Please find attached a supplement to the next meeting of **GREATER CAMBRIDGE PARTNERSHIP EXECUTIVE BOARD**, which will be held in **THE COUNCIL CHAMBER, THE GUILDHALL, CAMBRIDGE** on **WEDNESDAY, 26 JULY 2017** at **10.00 a.m.**

**6. Questions from Members of the Public**

## AGENDA ITEM 10 – MILTON ROAD BUS PRIORITY

## Chart 2

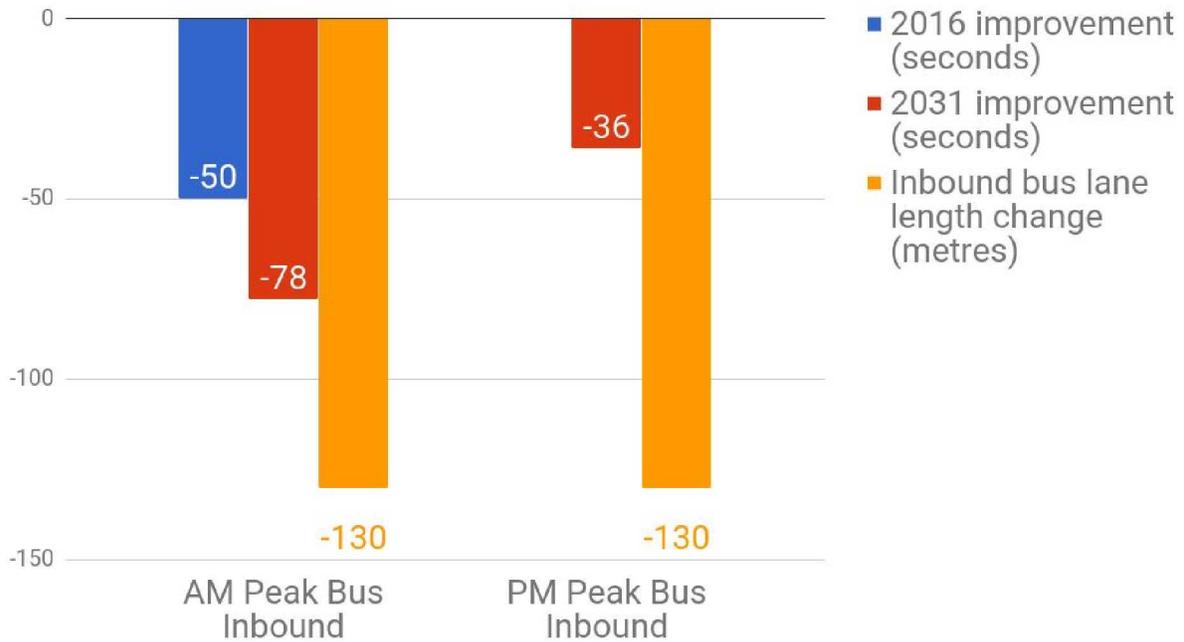
Focusing on the bus results: inbound bus journey times improve even as the inbound bus lane is shortened, compared to 'Do Nothing'. Morning inbound bus journeys are predicted to see the most improvement, and continue to improve through 2031. Evening inbound bus journeys in 2031 are also better than 'Do Nothing'. The comparison figures for 2016 bus journeys are not written into the report so they cannot be shown here. We believe that further shortening of bus lanes can be undertaken without overly affecting bus journeys.

## Example from the report: Gilbert Road Junction (2031)

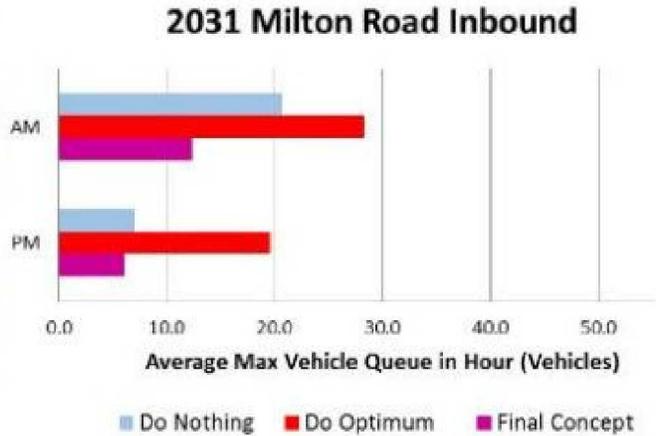
Predicted average maximum motor vehicle inbound tailbacks for 'Final Concept' in the morning and evening are 12 and 6 vehicles respectively, both better than any other alternative. Current 'Final Concept' plans for the bus lane approaching Gilbert Road inbound call for it to be about 40 car-lengths long, far more than could ever possibly be needed.

This diagram shows the length of a 12 car queue at Gilbert Road junction, which is the predicted average maximum tailback in 2031. Significantly shorter than proposed bus lane.

And in reality, the existing bus lane on Milton Road approaching Gilbert Road today is almost entirely unused by buses, save for when they have to pull into a bus stop.

## Example from the report: Arbury Road Junction (2031)

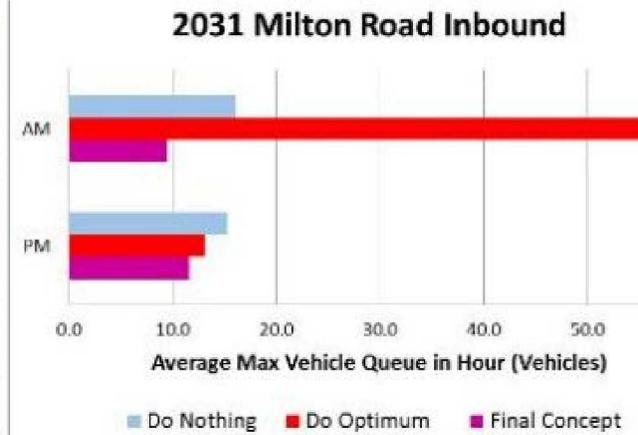
Predicted average maximum motor vehicle inbound tailbacks for 'Final Concept' in the morning and evening respectively are 9 and 12 respectively, both better than any other alternative. Current 'Final Concept' plans for the bus lane approaching Arbury Road inbound call for the bus lane to be about 140 car-lengths long, all the way back to Woodhead Drive.

This diagram shows the length of a 12 car queue at Arbury Road junction, which is the predicted average maximum tailback in 2031. Significantly shorter than proposed bus lane.

In reality, longer inbound queues tend to form at this junction when a motorist is stuck trying to make a right turn onto Arbury Road: that one car can hold up the whole queue for an entire traffic light cycle, and lead to a build-up. This technical problem is corrected by both 'Final Concept' and 'Do Optimum' and should not be a cause of queues anymore after the new scheme is implemented.

## Example from the report: King's Hedges Road junction (2031)

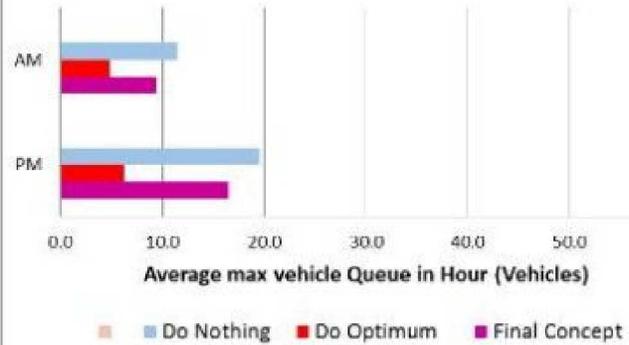
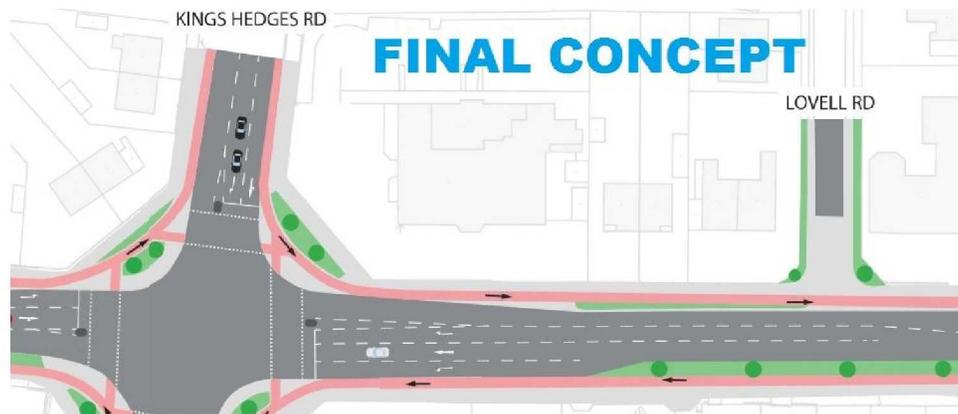
Predicted average maximum motor vehicle inbound tailbacks for 'Final Concept' in the morning and evening respectively are 10 and 16 respectively, both better than 'Do Nothing' but both worse than the roundabout proposed in 'Do Optimum' (to be fair, the model says that this advantage for 'Do Optimum' comes at the expense of long queues on King's Hedges Road).

Current 'Final Concept' plans do not propose a bus lane approaching King's Hedges Road junction at all, but in this case the 'Do Optimum' plan does propose an inbound bus lane leading towards this junction inbound on Milton Road. This is an example where the modelling reveals that 'Do Optimum' may have proposed an excessive length of bus lane.

Diagram (I)

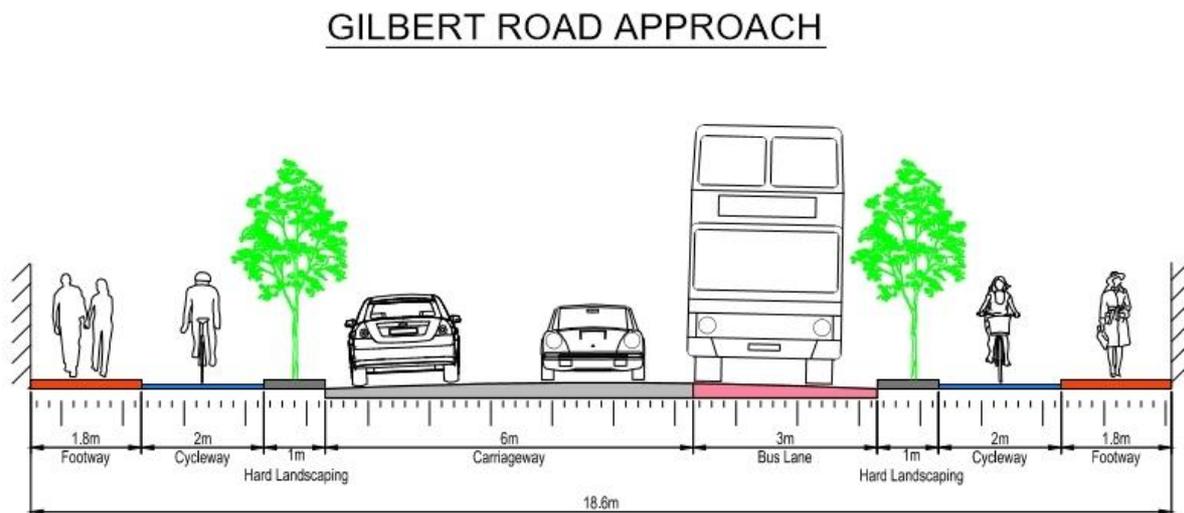
**Note:** these specific diagrams are chosen because they illustrate the safety point being made by the question. Other cross-sections published exhibit the same issues.

**Preamble:** It seems that there is insufficient space to meet everyone's requirements. There is a trade-off between commuter convenience, pedestrian and cyclist safety, and environmental beauty. In all of these, it is generally agreed that **safety must come first**.

From Diagrams (I) and (II) it is clearly evident that if one adds in the vehicle wing mirrors, then 3m-wide lanes would **not be wide enough** to support 3 vehicles of bus-width passing alongside each other. To avoid an accident there is a danger in Diagram (II) of a bus veering into the cycle lane (easily mounting the verb) and fatally injuring a cyclist, or forcing a cyclist to veer into the pedestrian walkway and injuring a pedestrian.

### GILBERT ROAD APPROACH

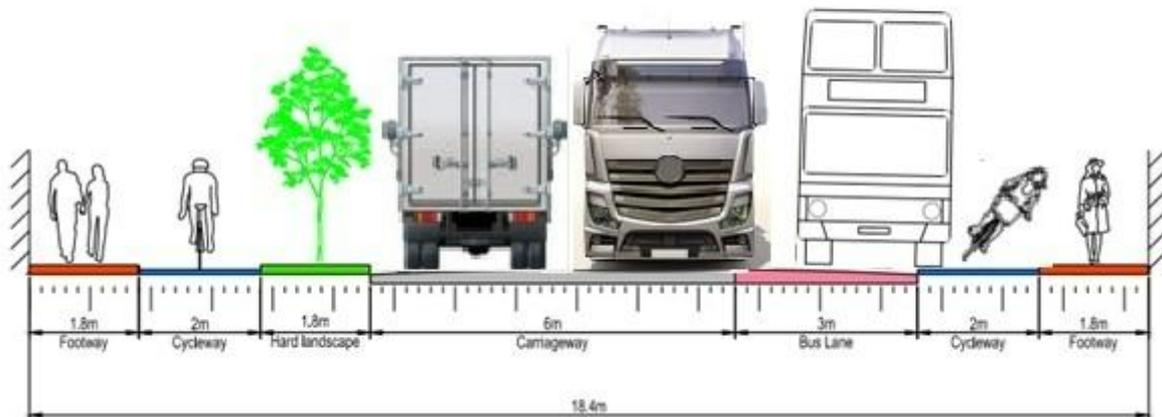
**Observation:** A tree/verge barrier as in Diagram (I) separating traffic from stylists **is essential for the safety** of both cyclists and pedestrians.

**QUESTION:** What measures are being prioritised to ensure the safety of cyclists and pedestrians?

If it is decided that the road-space is inadequate to support 3 motorised lanes, will the design team either:

- **REMOVE** the bus lane from the design;
- OR
- **RESTRICT THE WIDTH** of vehicles using Milton Road, effectively banning use by wide lorries.
